SERVICE BULLETIN

M1610 (REV A): RECALL 0184 - 2023 CVO STREET GLIDE (FLHXSE) AND ROAD GLIDE (FLTRXSE) BRAKE LINE CLAMP

Figure 2. P-Clamp Orientation

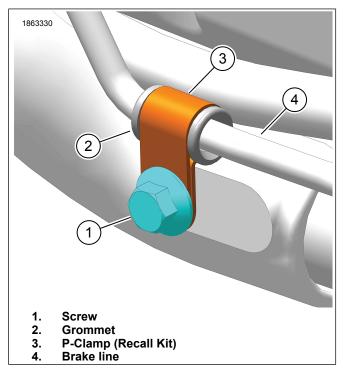
- 1. See Figure 1. Remove and retain screw (1).
- 2. Remove and discard Original Equipment (OE) brake line clamp (2).
- 3. See Figure 2. Install **new** P-Clamp (3) from recall kit (Part No. 91500116).
 - a. Make sure P-Clamp (3) is properly orientated.
- 4. Install screw (1). Tighten.
